PRODUCT BULLETIN

Bulletin No: PB374

NEW G2 Series Blades for the HAKKO FT-801 Thermal Wire Stripper

G2-A1601, G2-A1602, G2-A1603

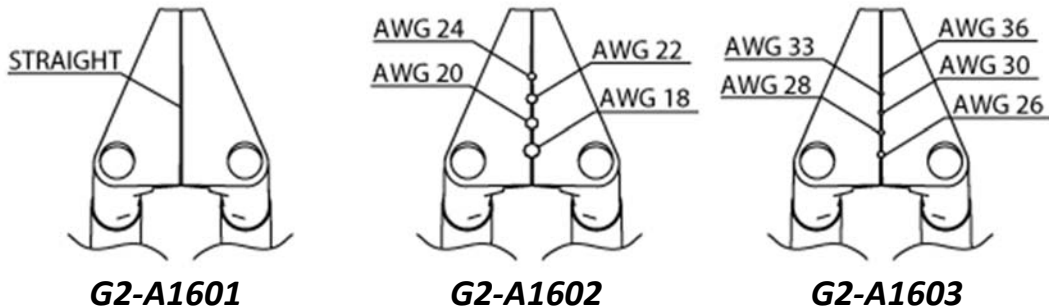
These new G2 Blade Sets for the HAKKO FT-801 Thermal Wire Stripper include a wishbone support between them that is attached to the collar. This support mitigates rotational play in the blades to improve notch alignment at the end of the blades when tighter tolerances are required.
